工程指示 / 要求簡箋(E.I.)

工程指示編號：EI / 6434 / 23

工程名稱：將軍澳日出康城 11

工程項目：幕牆 配件 大梗頂 唧黑膠

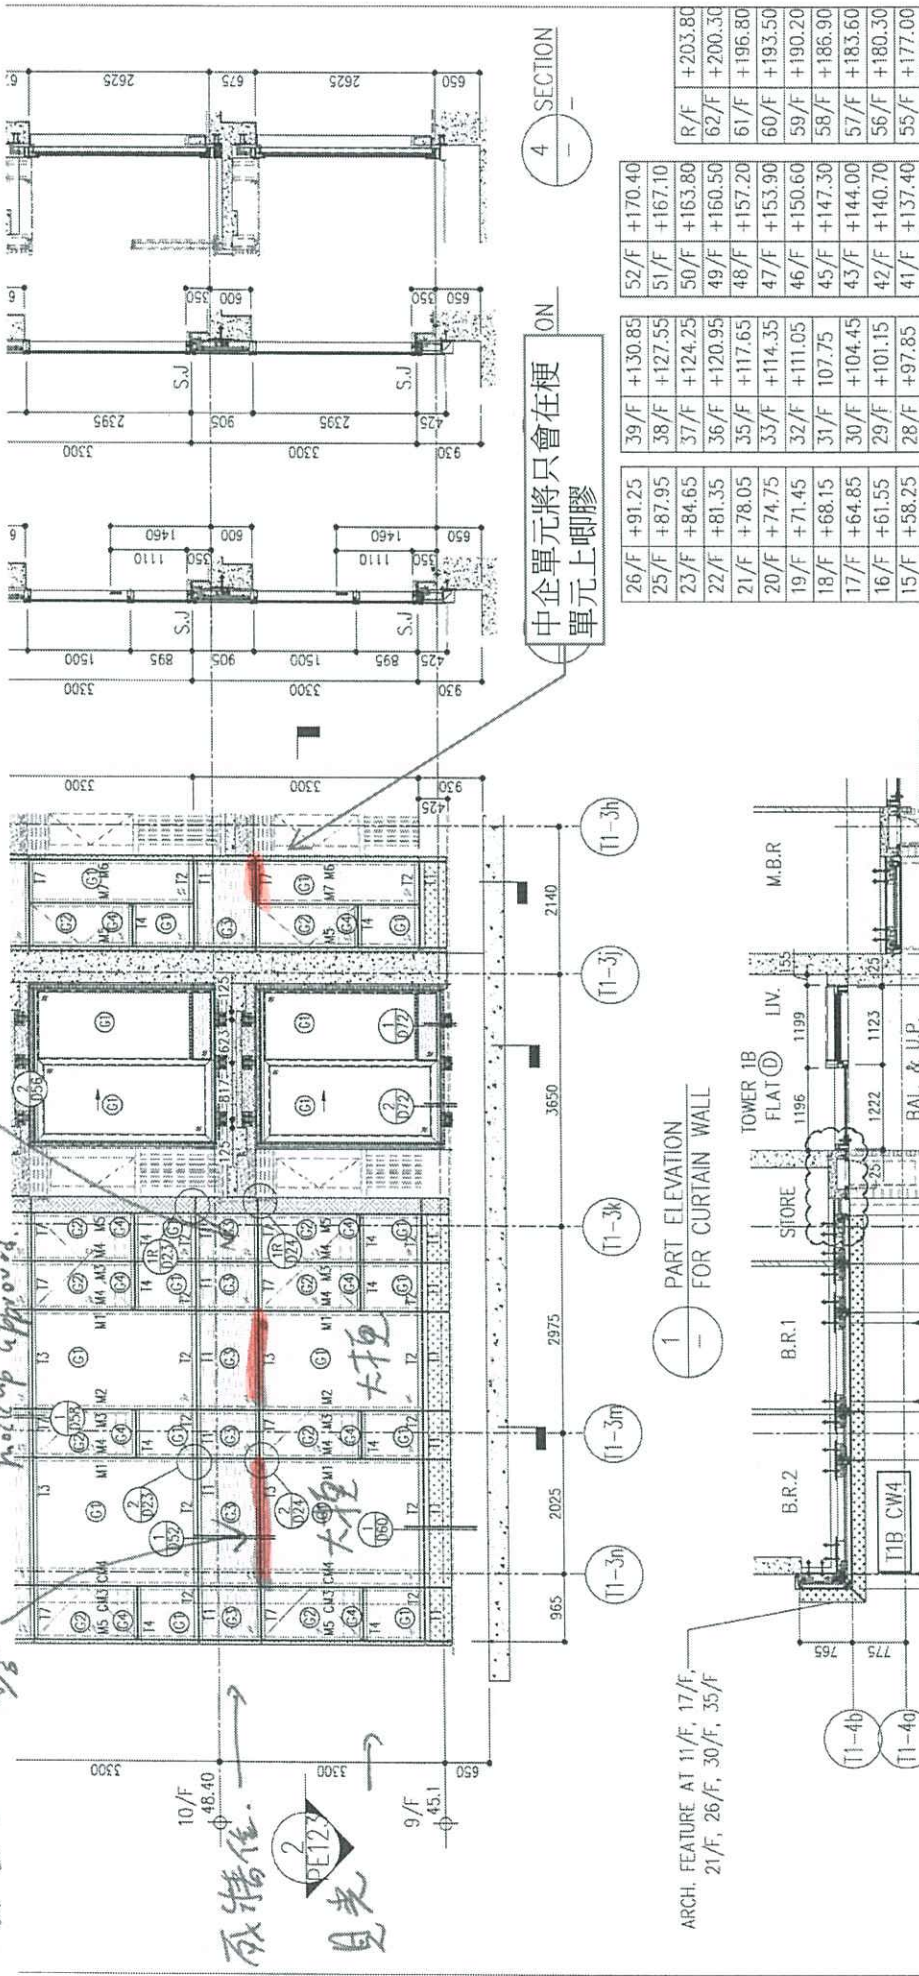
死構位與大柱之間

哪邊包不包膠 subject to 7/4

鑄造不能包膠

Mockup approved

取構位
見光

中企單元將只會在便
單元上膠

1 PART ELEVATION FOR CURTAIN WALL

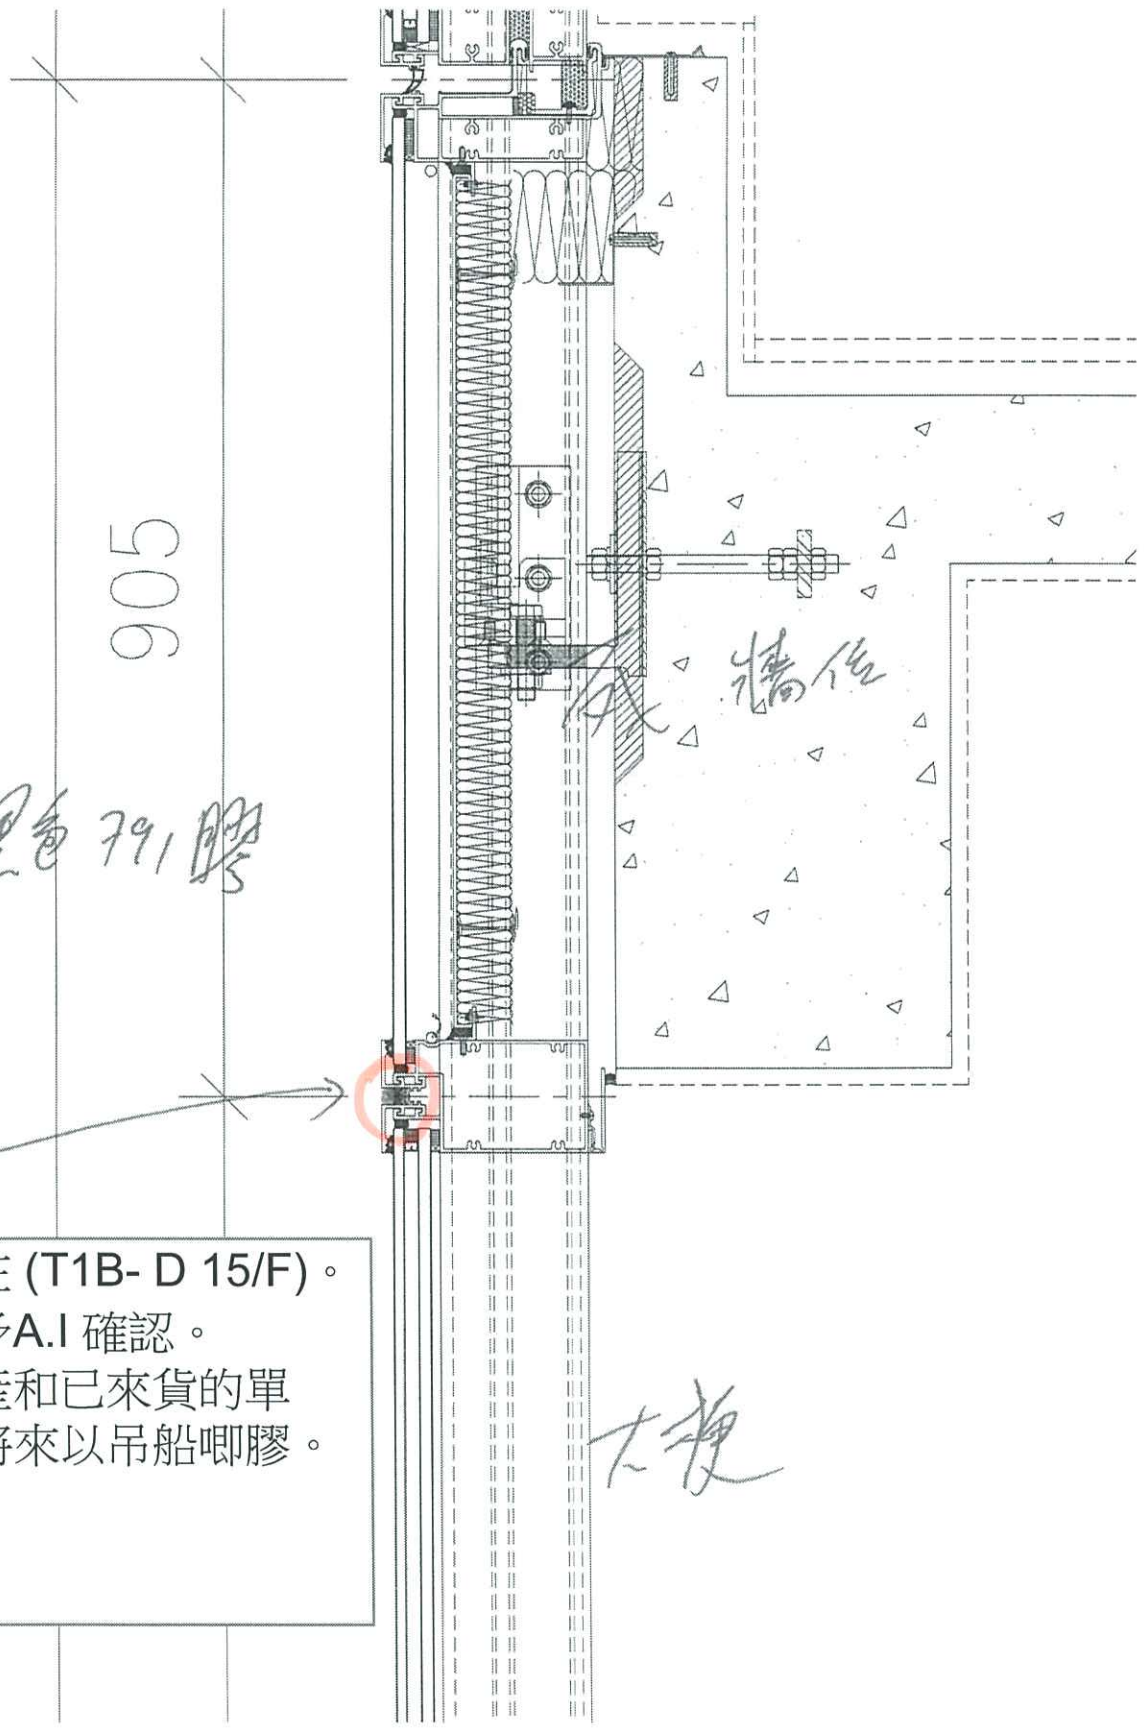
A 版: 確定使用黑色給死牆位置的梗玻璃和飾線位，加附節點，

包括 Glass cladding 及幕牆單元。

→ T1 31-35F 36-40F 用黑色
→ T2 361F 開始, T3 361F 開始

1. 由於業主要求，幕牆 大梗頂改用黑色。請計算唧膠總長度及使用黑膠數量

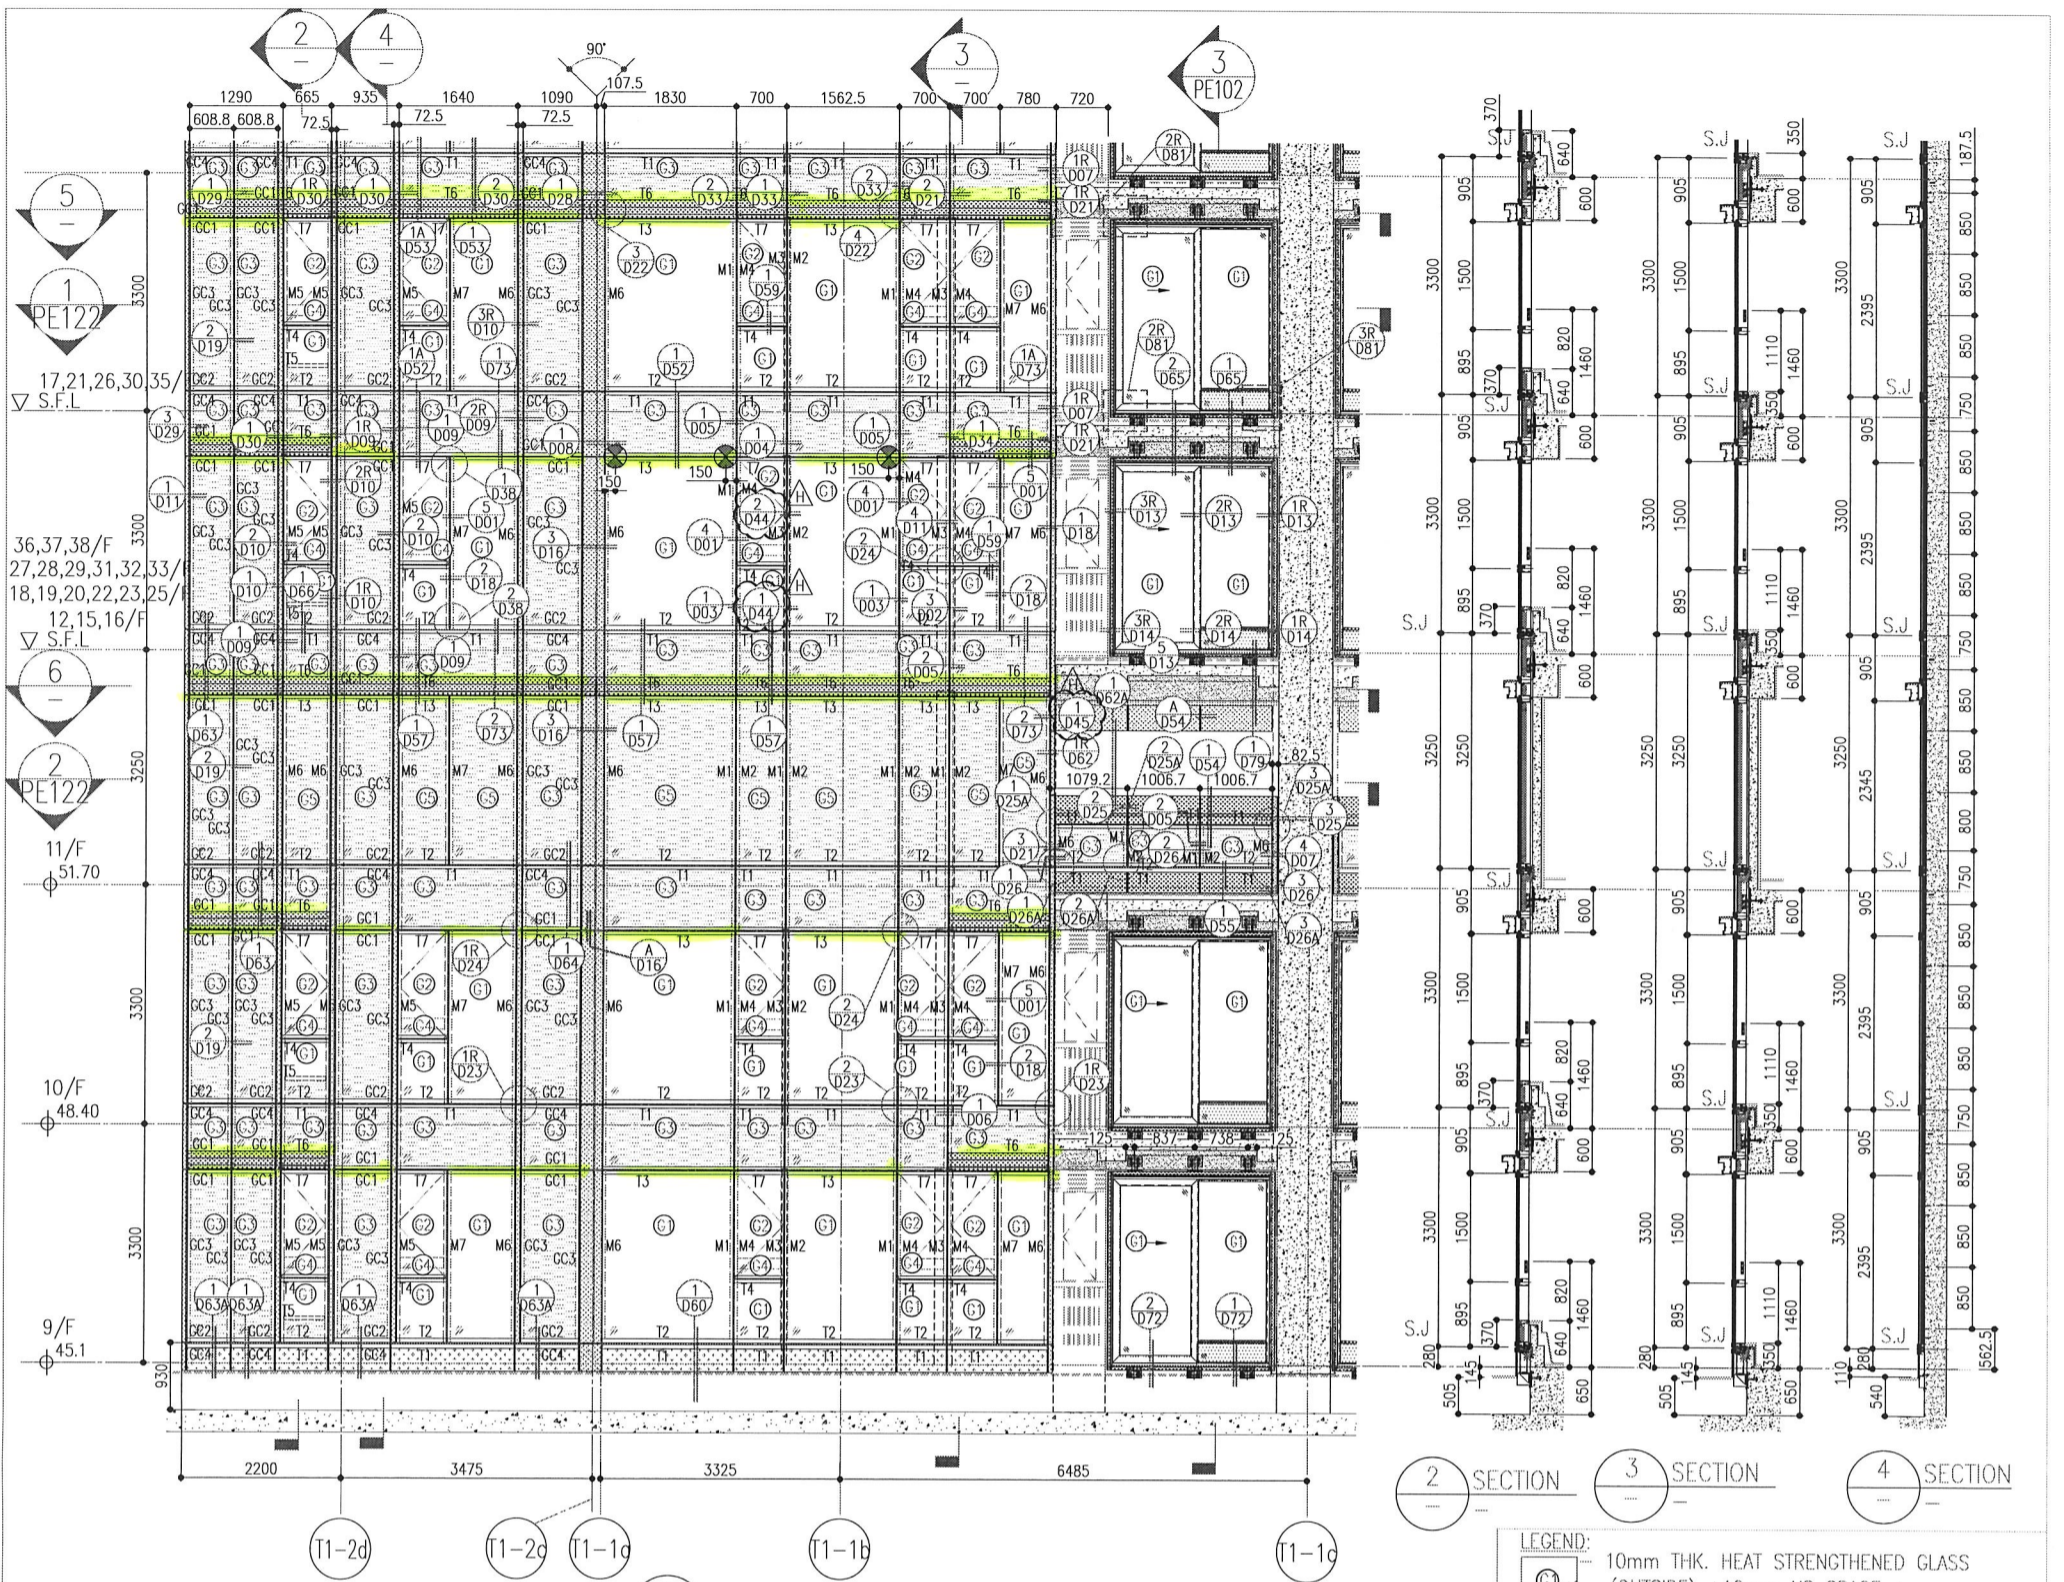
大柱留頂上膠

啞黑色 791 膠

牆位

樣板在 (T1B- D 15/F) 。
 請給予A.I 確認。
 已生產和已來貨的單
 元，將來以吊船啞膠。
